AL SUMELAT  
WATER NETWORK  
VILLAGE OF AL SUMELAT, IRAQ

**SIGIR PA-05-004**  
**MARCH 15, 2006**

## **Al Sumelat Water Network Village of Al Sumelat, Iraq Synopsis**

**Figure 1: Al Sumelat Pipeline Location Map**

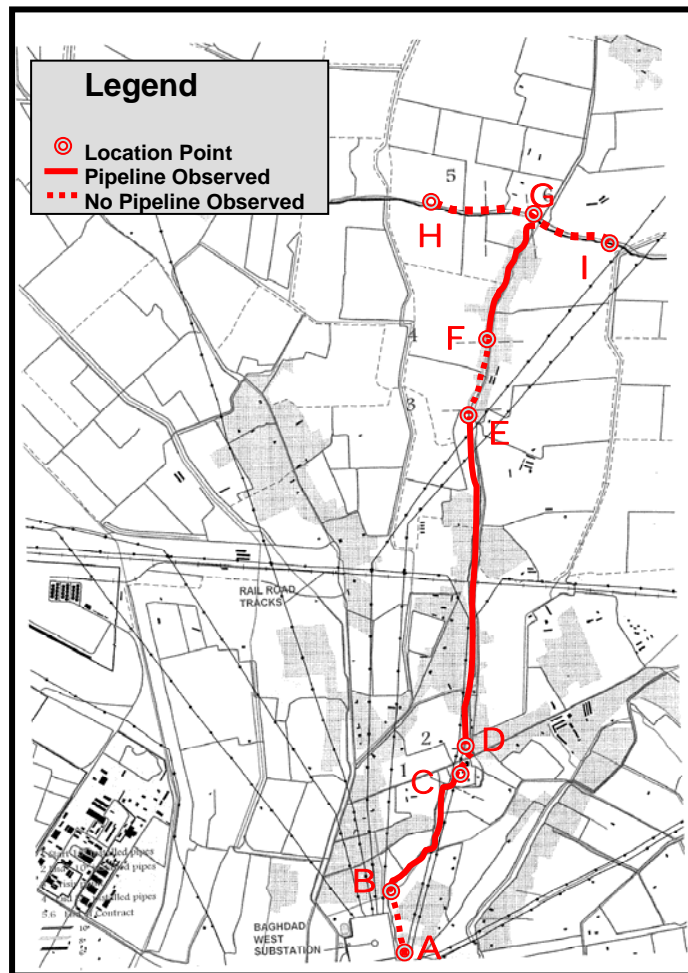
**Point A to B:** The approximate length of the pipeline from point A to point B (see the locator map in Figure 1 on page 4) is 840 meters. Disturbed soil leading in the direction of the pipeline route was observed from point A. The disturbed soil appeared to be the result of a recent trench excavation and subsequent backfilling of the trench (Site photo 2). It could not be determined how far this excavation continued. The starting point of the pipeline was not visibly protruding from the disturbed soils and could not be located at point A. An observation at point B leading back toward point A along the proposed pipeline path was of an open field showing no recently disturbed soil (Site photo 3). Consequently, no evidence that the pipeline had been installed between points A and B was found.

**Point B:** Point B on the locator map in Figure 1 on page 4 is the point at which the pipeline route crosses underneath an irrigation canal. A recently excavated tunnel approximately 1 meter by 1/2 meter was observed underneath the irrigation canal. The pipeline was not visible leading into (Site photo 4) or exiting the

**Point B to C:** The approximate length of the pipeline from point B to point C (see the locator map in Figure 1 on page 4) is 1,495 meters. Uncapped endpoints of the pipeline were observed at both points B and C (Site photos 5 & 6). The pipe diameter looked to be approximately 225 millimeters, but accurate measurements were not obtained at this location. Disturbed surface soil was observed continuously between points B and C along the proposed pipeline route. The disturbed soil appeared to be the result of a recent trench excavation and subsequent backfilling of the trench. A sand base was not present at the endpoints of the pipeline. A significant amount of unconsolidated soil was observed above grade along the pipeline path. Lack of compacting during backfilling operations would result in the presence of the observed excess soil. The surface of the disturbed soil was uneven with several feet variation in height along the pipeline route. This indicates that final surface grading was not completed. It appeared, based on site assessment observations, that the pipeline had been installed between points B and C, but the pipeline installation was not consistent with contract requirements.

**Point C to D:** The approximate length of the pipeline from point C to point D (see the locator map in Figure 1 on page 4) is 110 meters. The pipeline route crosses a road intersection at this location. A recently excavated tunnel approximately 1 meter by ½ meter was observed beneath the road intersection.

**Point D to E:** The pipeline leg from point D to point E (see the locator map in Figure 1 on page 4) is approximately 3,389 meters in length. This section parallels the road and crosses underneath a set of railroad tracks. The endpoint could not be located at point D and an uncapped endpoint of 225 millimeter diameter pipeline was observed at point E. Disturbed surface soil was observed continuously between points D and E along the proposed pipeline route. The disturbed soil appeared to be the result of a recent trench excavation and subsequent backfilling of the trench. A sand base was not present at the endpoints of the pipeline. A significant amount of unconsolidated soil was observed above grade along the pipeline path. Lack of compacting during backfilling operations would result in the presence of the excess soil. The surface of the disturbed soil was uneven with several feet variation in height along the pipeline route. This demonstrates final surface grading was not completed. It appeared, based on site assessment observations, that the pipeline had been installed between points D and E, but the pipeline installation was not consistent with contract requirements.

**Point E to F:** The pipeline leg from point E to point F (see the locator map in Figure 1 on page 4) is approximately 703 meters in length. This section parallels and crosses under the roadway. A recently dug open trench approximately 1 meter in depth was observed along the proposed pipeline route. Pipe was not visible and the bottom of the trench excavation appeared to be undisturbed soil. At the location where the proposed pipeline route crosses underneath the road a recently excavated tunnel, approximately 1 meter by ½ meter was observed. The pipeline was not visible and could not be located leading into or exiting the tunnel. The bottom of the tunnel excavation appeared to be undisturbed soil. Consequently, no evidence that the pipeline had been installed between points E and F was found. Prior to the site visit, this section of the pipeline was identified as not being completed by the USACE Quality Assurance Representative and is listed in this report under the section on “Work Pending.”

**Point F to G:** The pipeline leg from point F to point G (see the locator map in Figure 1 on page 4) is approximately 1,315 meters in length. Uncapped endpoints of a 225 millimeter pipeline were seen at both point F and point G. A short section of the pipeline trench, which was only partially backfilled, clearly indicated that sand base was not used (Site photo 7). Disturbed surface soil was observed along the remainder of the proposed pipeline between point F and G. The disturbed soil appeared to be the result of a recent trench excavation and subsequent backfilling of the trench. A significant amount of unconsolidated soil was observed above grade along the pipeline path. Lack of compacting during backfilling operations would result in the presence of the observed excess soil. The surface of the disturbed soil was uneven with several feet variation in height

**Point H to I:** The pipeline leg from point H to point I (see the locator map in Figure 1 on page 4) is approximately 2,571 meters in length. A recently dug open trench approximately 1 meter in depth was observed along the proposed pipeline route. Pipe was not visible and the bottom of the trench excavation appeared to be undisturbed soil. Consequently, no evidence that the pipeline had been installed between points H and I was found.

No work was in progress at the time of our site assessment on July 3, 2005. The contractor was not on site during the site assessment. The only equipment observed near the site was a backhoe located adjacent to the open trench excavation near point I, in Figure 1 on page 4. Materials required for the completion of the project were not observed anywhere along the proposed pipeline route.
